Re: James A. FitzPatrick Nuclear Power Plant

The Commission has issued the enclosed Amendment No. 65 to Facility Operating License No. DPR-59 for the James A. FitzPatrick Nuclear Power Plant. This amendment consists of changes to the Technical Specifications in response to your application dated January 6, 1982.

Amendment No. 65
License No. DPR-59

ATTACHMENT TO LICENSE AMENDMENT NO. 65

FIGURE 6.1-1

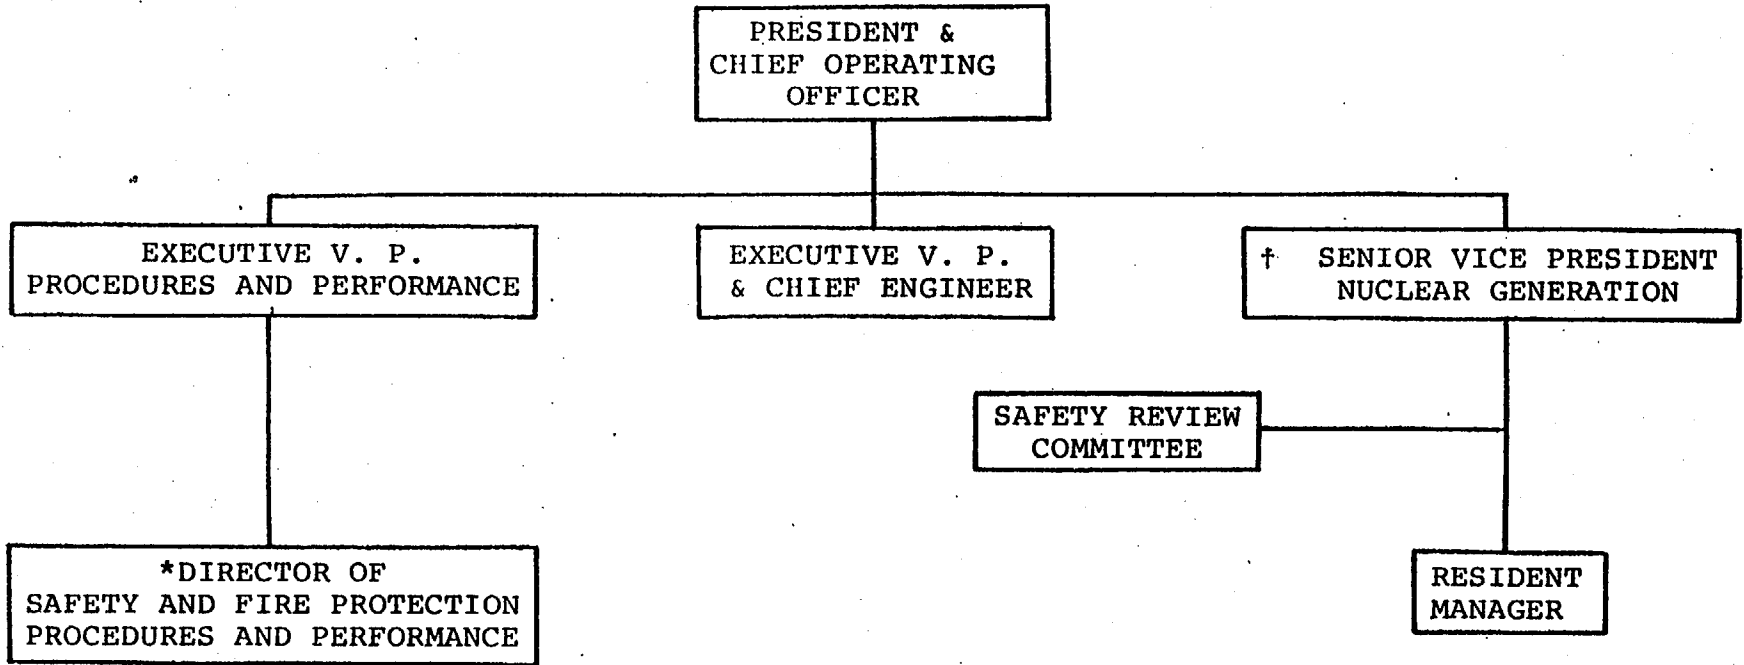
The amendment revises the provisions in the Technical Specifications to allow the reorganization of the FitzPatrick Safety Review Committee. In essence, personnel titles and reporting requirements have been changed in order to clarify responsibilities. Using various tools, such as the Task Action Plan, Regulatory Guide 1.33 and ANSI 18.7/ANS 3.2 guidelines, we reviewed the James A. FitzPatrick management organization to assure that the proposed change does not diminish the level of safety with respect to organization and technical resources provided by the existing Technical Specifications.

1. Revise Appendix A Technical Specifications as follows:

Figure 5.2-2
 Management Organization-Offsite
 Radiological Environmental
 James A. FitzPatrick Nuclear
 Power Plant

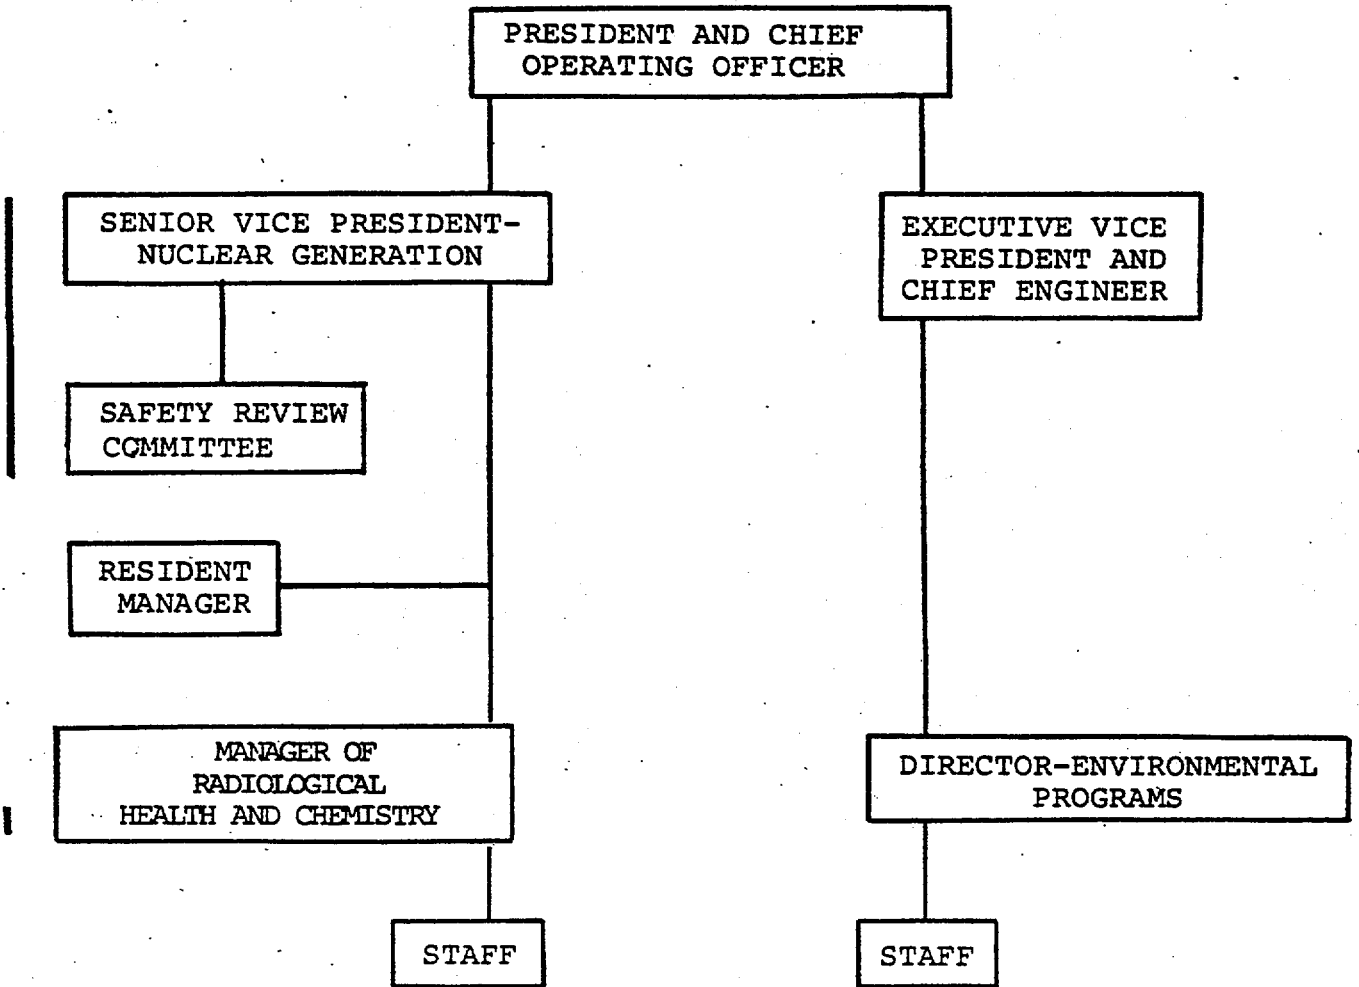
2. Revise Appendix B Technical Specifications by removing page 44 and inserting revised page 44.
